Docket No. 50-423

Millstone Nuclear Power Station, Unit No. 3
Probabilistic Safety Study (PSS)

The above reference requested Northeast Nuclear Energy Company (NNECO) to submit additional information which resulted from the staff's review of information contained in Amendment No. 2 to the Millstone Unit No. 3 PSS. Enclosed please find documentation of all questions posed to NNECO along with our formal responses herein. We trust you will find this information fully responsive.

FIGURE 720.78-1. COMPARISON OF PEAK GROUND VELOCITY TO PEAK GROUND ACCELERATION RATIOS WITH MEDIAN SITE-SPECIFIC RESPONSE SPECTRUM

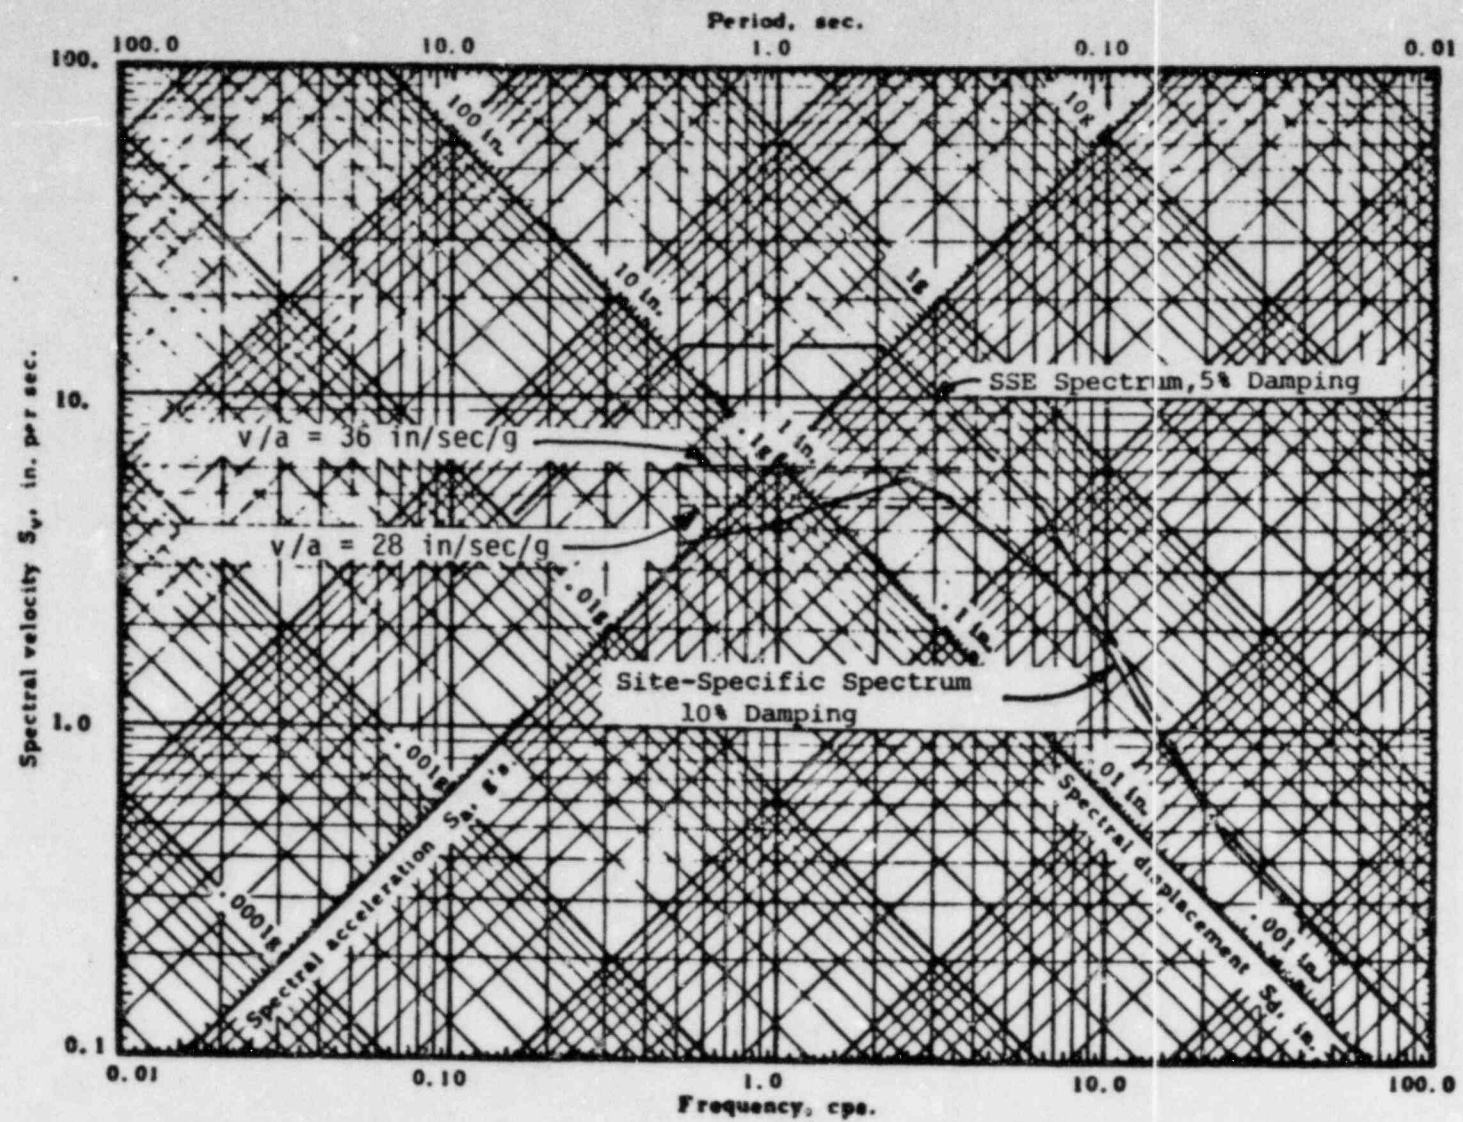
The staff questions the validity of using a peak bedrock velocity of 28 in/sec/g for the calculation of sliding-induced failure. This value is inconsistent with both that recommended by Newmark and Hall (NUREG/CR-0098, 1978), and that calculated directly for the Millstone site reported in NUREG/CR-3756 (see Question 3). Additionally, the value of 28 in/sec/g based upon only a few Western United States strong motion records may not be appropriate for the Eastern United States where attenuation characteristics are different. Provide a response to these concerns, and if necessary, revise your estimates of fragilities due to sliding-induced failure.

As shown in Figure 720.78-1, the median ten percent damped amplified ground response spectrum is exceeded by this velocity for frequencies less than about 1.4 Hz and greater than about 3.4 Hz. The peak ground velocity for the conservative v/a ratio of 36 in/sec/g, scaled to SSE peak ground acceleration, is:

As shown in Figure 720.78-1, the median ten percent damped ground response spectrum is exceeded by this peak ground velocity through the entire frequency range. This occurrence is not substantiated by real earthquakes.

Inspection of Figure 720.78-1 would imply a median v/a ratio somewhat less than 28 in/sec/g. It can be concluded that the selected median v/a ratio of 28 in/sec/g, while somewhat conservative, is more appropriate for use in the Millstone 3 fragilities evaluation than the conservative design value of 36 in/sec/g.

FIGURE 720.86-1a. TYPICAL CROSS-SECTION THROUGH CONTROL BUILDING FOUNDATION

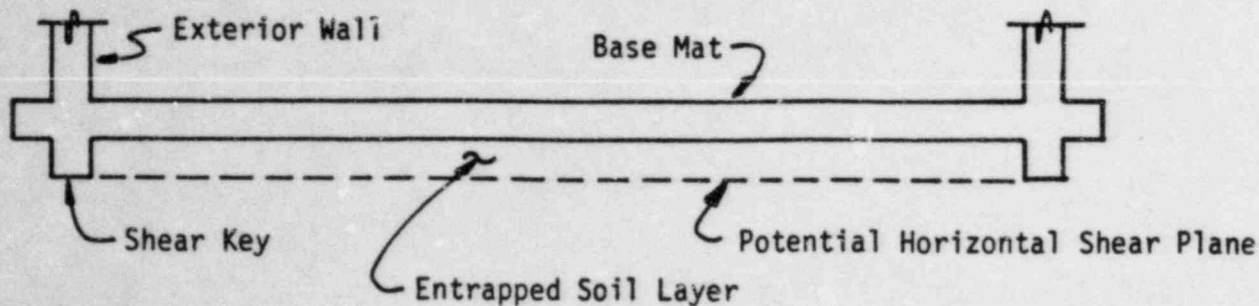
Your sliding analyses of the control building and the emergency generator enclosure may be nonconservative. We believe you assumed the shear resistance equals the arithmetic sum of the soil friction resistance and the flexural strength of the shear keys. Provide a basis for such an assumption or reanalyze using a failure plane developed along the bases of the shear keys which cut through the soil.

The control building is supported on a single base mat typically 4'-0" thick. The base mat bears on one to four feet of compacted structural backfill overlying basalt fill varying from one to fifteen feet in thickness. Shear keys into the soil were provided beneath the exterior walls. A typical cross-section through the control building foundation is shown in Figure 720.86-1a.

FIGURE 720.87-1. MEDIAN SITE-SPECIFIC GROUND RESPONSE SPECTRUM

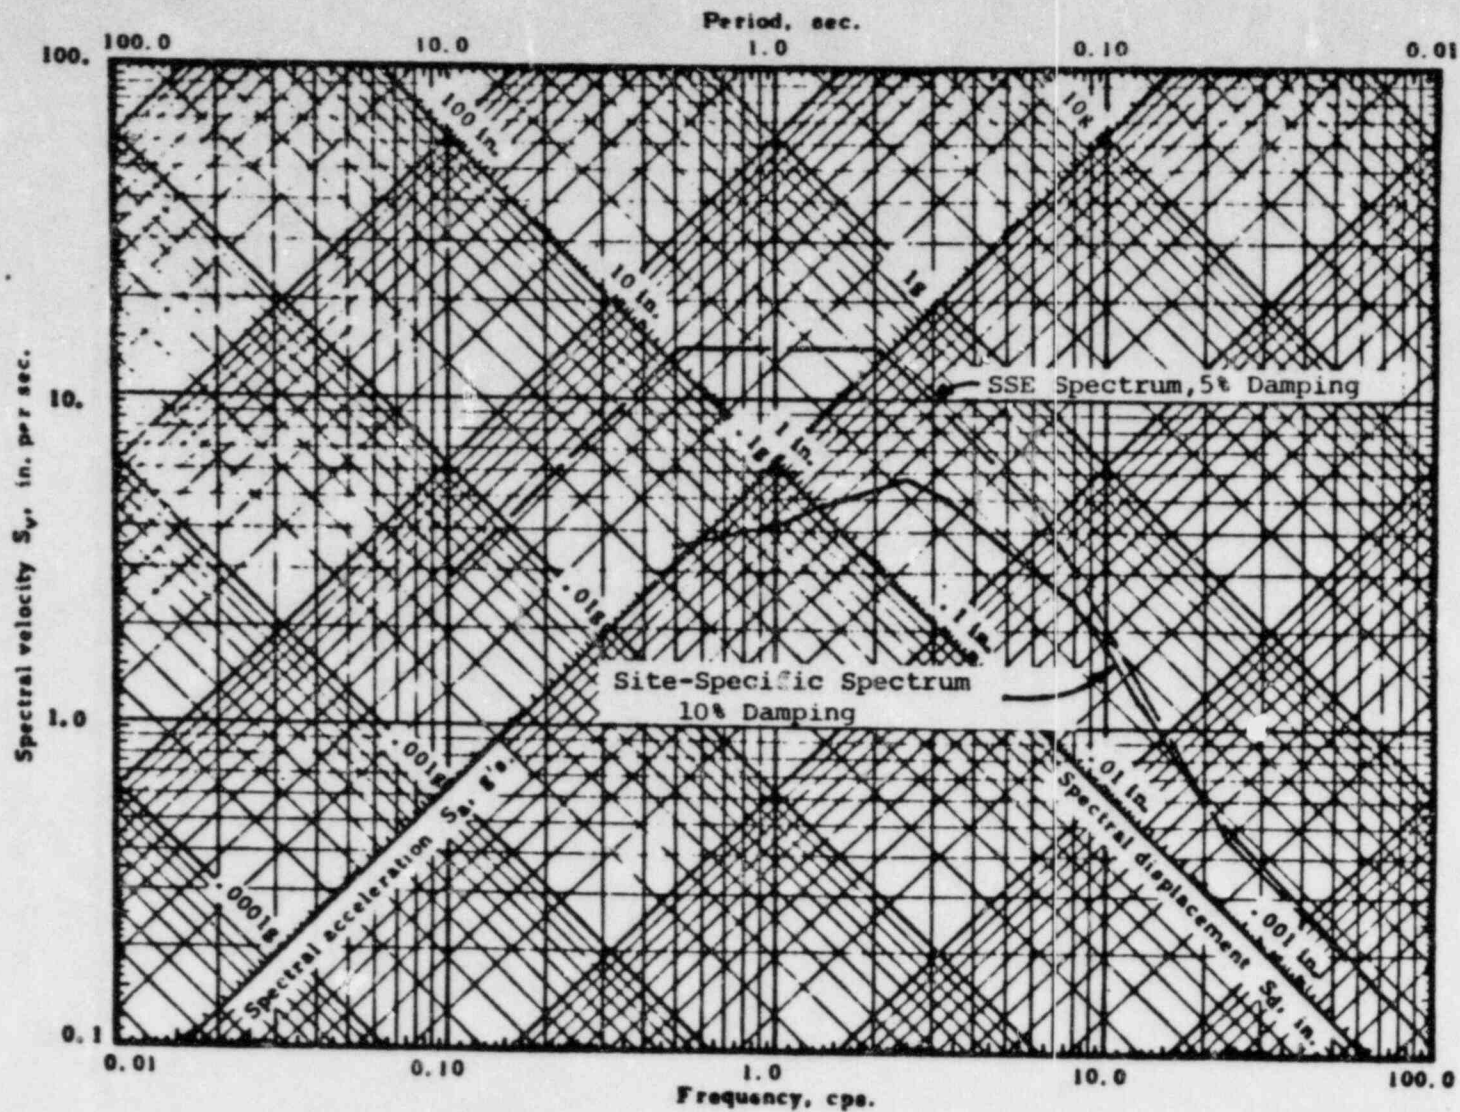
We believe your analysis of the emergency generator enclosure assumed the foundation was anchored in till. We understand the enclosure actually has a foundation partly on till, partly on fill, and partly on till and fill. We believe a new analysis, taking into account as-built conditions, may show your analysis is optimistic. Demonstrate your analysis is not overly optimistic.

If the original design seismic analysis assumed that the emergency generator enclosure was founded on basal till rather than a combination of backfill and till, reductions in the frequencies from these values originally calculated would be implied. The structure failure modes having the lowest median acceleration capacities result from north-south seismic response. Inspection of the in-structure response spectra shown in FSAR Figures 3.7 B-52, 55, and 58 indicate that modes having frequencies of about 9 Hz and 14 Hz contribute the most to response in this direction. Spectral accelerations at these frequencies for the median-centered, site-specific ground response spectrum can be obtained from Figure 720.87-1 (taken from Figure 3-1 of Reference 1). The spectral accelerations are nearly uniform at the maximum value around the fundamental frequency of approximately 9 Hz. In fact, a reduction in response would be expected if a revised representation of the soil stiffness resulted in a fundamental frequency less than about 8 Hz since spectral accelerations begin to decrease at this value. A slight increase in the seismic response associated with the second mode would be expected. However, significant change in the second mode response would require a substantial reduction in the soil stiffness.

Seismic response of the emergency generator enclosure is a function of the combined stiffness of the soil-structure system. The stiffness of the structure itself is independent of the soil conditions beneath the foundation. The soil stiffness is directly influenced by the representation of the material beneath the structure. However, because the soil-structure system frequency is a function of the square root of the system stiffness and the system stiffness is a combination of the separate soil and structure stiffnesses, representation of the soil median as being composed of basal till rather than till and backfill is not expected to lead to a significant change in the emergency generator enclosure fragilities. Possible uncertainty in the soil-structure representation was accounted for by an increase in the variability associated with this mode of failure.
